## Review 1

**2.3 MW base load-optimised wind turbine main bearing unit case study:**

**AHD steel hollow forged rotor shaft**

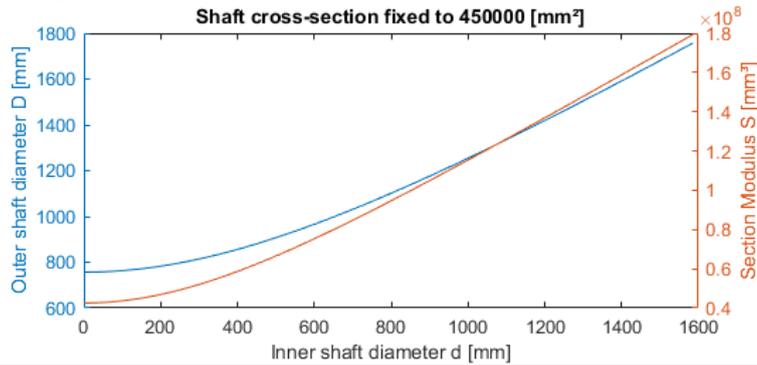
<b>RC 1</b>	<u>Line 18</u> Instead of the somewhat vague “greatly reduced” I think it would be better to state the figure from the Conclusions such as “reduced by X%”. Please see later comment on the Conclusions though regarding the exact percentage.
<b>AR</b>	We added the percentage to the line – the percentages refer to the mass of the machined shaft
<b>AC</b>	<u>Lines 17-18</u> For the hollow forged rotor shaft to be comparable to casting regarding manufacturing costs, the forging surcharges need to be <del>greatly reduced</del> <b>less than 50% of the shaft mass.</b>

<b>RC 2</b>	<u>Line 19</u> As noted in the Conclusions, I think it would be beneficial to the reader to add the caveat that “the GWP of hollow forging is comparable to casting and each are actually less than one-third of the GWP of the entire MBU.”
<b>RC 14</b>	<u>Line 18</u> I think it would be clearer to add “...the manufacturing GWP of hollow forging...”
<b>AR</b>	As the main bearings are quite heavy (oversized), the wording was changed to around one-third (the shaft share would be larger for smaller bearings) and added to the text
<b>AC</b>	<u>Lines 18-20</u> Due to the shortened heat treatment of AHD steels and the use of green steel, the <b>manufacturing GWP of hollow forging is comparable to casting and makes up around one-third of the GWP of the entire MBU.</b>

New Figure 1

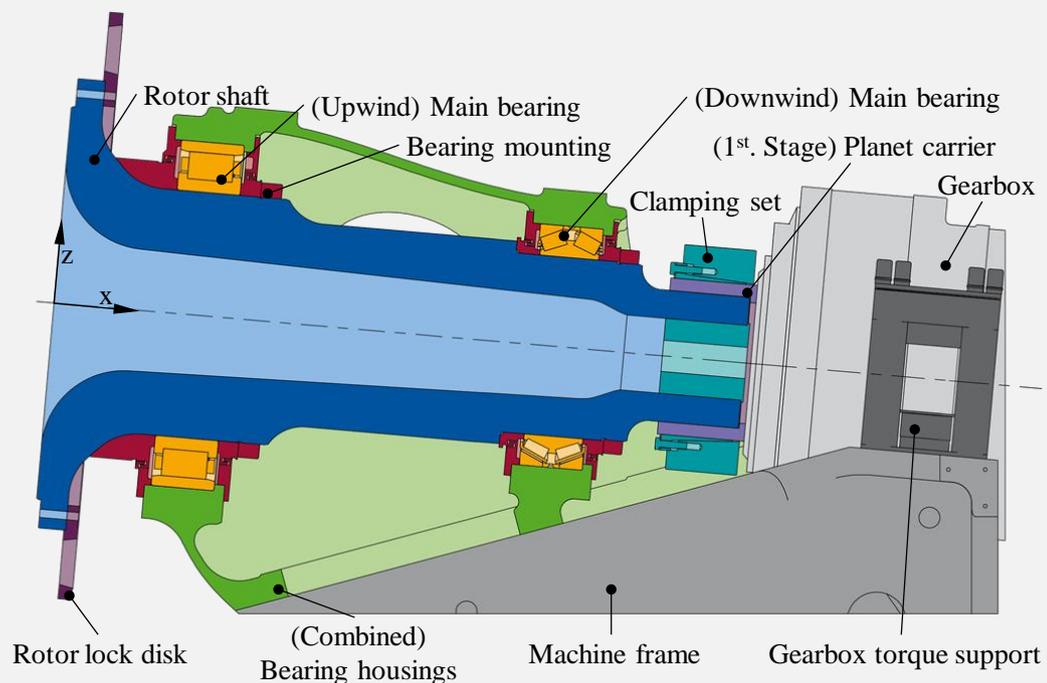
Terminology in this sentence, the figure, and the remainder of the paper are not quite the same, leading to a little bit of confusion. I believe it would be clearer to label both the “Upwind main bearing” and “Downwind main bearing” rather than just one “Main bearing” in the figure. Are the assembly components the same as the red components? Also, the “Machine frame” is labeled twice for both the green and grey components, with the green component (I think) called the “Main bearing housing” in the remainder of the paper (for example, in Section 3.3.3 and Table 5) and the grey component separate and not in the scope of the study. Additionally, the text states “The bearing housings...connect...gearbox to the azimuth bearing”. I don’t believe this is correct: as far as I can tell from the figure the gearbox is only connected to the grey “Machine frame”, but not the “Main bearing housing”. But I could be wrong here. It does not seem to be worth mentioning the azimuth bearing, as it is not shown in the figure and not in the scope of the paper either.

<b>RC 1</b>	<u>Figure 1</u> : I appreciate the changes made to the figure; however (it's very minor and sorry for missing it in the first review), I believe "(1st Stage) Planet Carrier" should point to the purple-colored element rather than the blue-colored Rotor shaft and the "Clamping set" should point to the aqua-colored element. Right?
<b>AR</b>	Yes, those two are switched => Labelling updated  (New Figure also inserted for Review 1 – RC 5
<b>AC</b>	<u>Figure 1</u> (new)

**AR** *Adjustment of bearing labels in Figures 1-3*

“Are the assembly components the same as the red components?” => Yes; for the other variants, they are indirectly considered through the bearing housing mass

*Adjustment of text and Figure 1 for better distinction between bearing housing and machine frame*

The bearing housings are **integrated into the combined into one cast machine frame, which is connected to the machine frame and connect both main bearings and the gearbox to the azimuth bearing of the nacelle** (see Fig. 1).

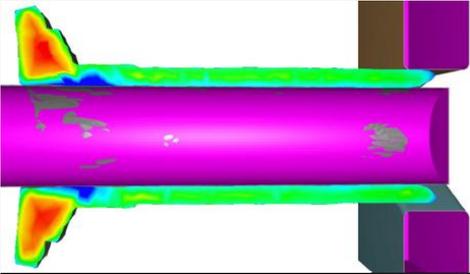
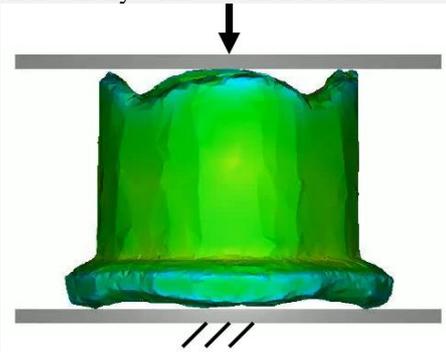
RC 9	<p><u>Line 242</u>  Again, not being an expert in this area, I am not familiar with the term "...axial upsetting". Can a brief description be added here? Does this refer to standing the shaft upright, such that gravity has some compressive effect on it?</p>
AR	<p><u>General summary of the forging steps:</u>  During hollow forging, the shaft is threaded on to a mandrel. Using a fixed die below and a moving die above, the material is compressed. This results in a reduction in diameter and an axial widening of the material.</p>  <p><i>Image: Hollow forging a shaft</i></p> <p>When forging the flange, the straight flange starts to deform into a funnel-shape. To ensure that the shaft geometry can be machined from the forging geometry, large axial surcharges (allowances) are needed.</p>  <p><i>Image: Funnel-shaping of the left-sided flange (forging simulation)</i></p> <p>To reduce the surcharges, it is necessary to straighten the flange. This is achieved by compressing the shaft axially without a mandrel inside.</p>  <p><i>Image: Straightening of the flange by axial upsetting the flange (forging simulation)</i></p>

By upsetting (compressing) the entire shaft in the axial direction between the forging steps, the flange area can be straightened, reducing the allowances required to compensate for the funnel-shaped collapsing flange areas and thus significantly reducing the masses in this area. <del>Axial upsetting between the stretching steps allows the flange area to be straightened in a targeted manner, reducing the required surcharges to compensate bending deformations and therefore lowering the masses in this area significantly.</del>
--	--

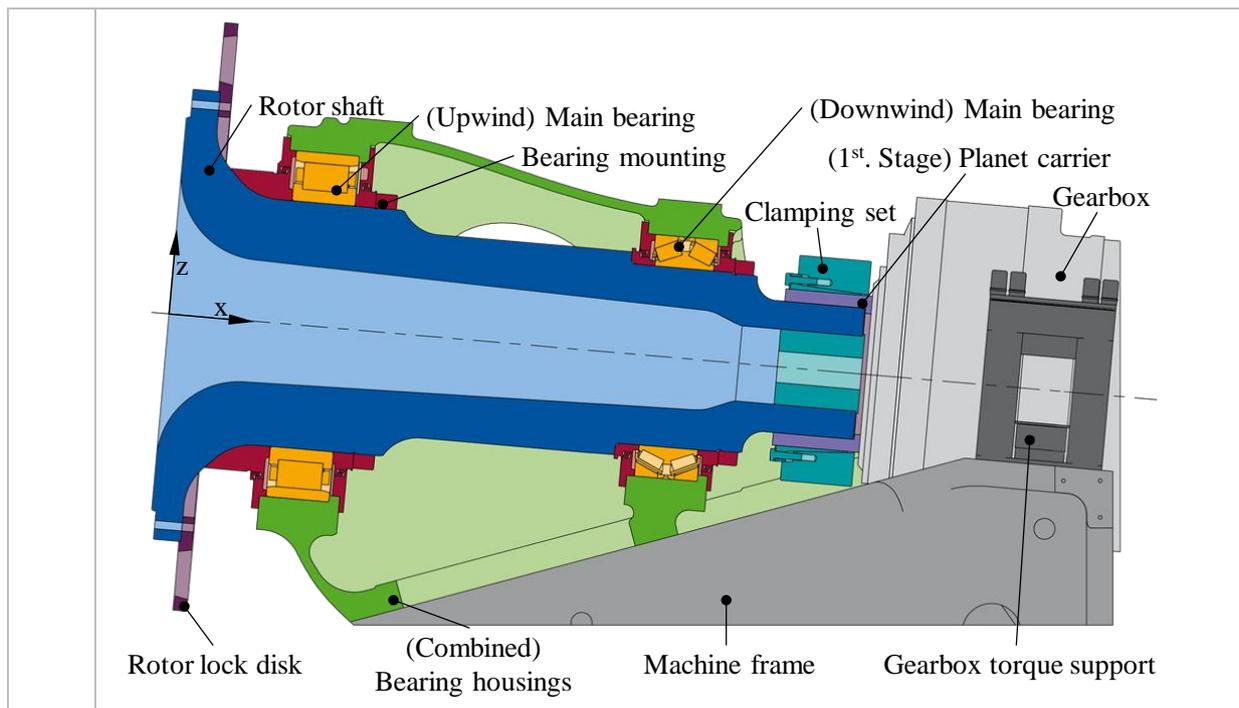
<b>AC</b>	<p><u>Lines 113-114</u>  Likewise, the cyclic hardening justifies that no additional safety margin is required when deriving fatigue strengths through the FKM-Guideline.</p>
<b>RC</b>	<p><u>2. Lack of Reliability Analysis</u>  The paper addresses structural integrity well, however there is no formal reliability-based design or probabilistic treatment of uncertainties (uncertainty quantification; e.g., in loads, material properties, forging tolerances). This limits confidence in the robustness of the design.</p>
<b>AR</b>	<p>The paper presents a predesign study. The presented hollow forged rotor shaft therefore must be refined in later design phases if it should be integrated into the <i>maxcap141</i> – e.g. a deformation analysis including the housings/machine frame, designing the bearing mounts.</p> <p>Comparing two predesigns (cast vs. hollow forged) allows load uncertainties to be neglected, as both predesigns use the exact same load cases. (Sidenote: the <i>maxcap141</i> shaft was designed considering multiple load cases from wind loads, assembly, ..., from which the worst static and a damage equivalent dynamic load case was derived for the predesign – the loads are therefore also conservative).</p>

<p>The forging surcharge are quite conservative to ensure that the final shaft geometry can be machined from the forged geometry. This results in worse material properties as the wall thickness is larger, cools slower and makes the shaft (currently) not economical.</p> <p>The material properties of the AHD alloy are currently based on lab tests/samples (e.g. tensile testing). To use the alloy in wind turbines, it must be certified (broadly tested) such that the material properties are validated.</p> <p>It is therefore believed that the shown mass reduction can be achieved using an AHD steel hollow forged shaft and through optimising the bearings even more.</p> <p><i>See also Review 3 – RC 3</i></p>
<b>AC</b>	<p><u>Lines 114-115</u> As the material properties are based on lab samples, <del>as</del> broad testing is required before the alloy is used in WTs to ensure reliability.</p>
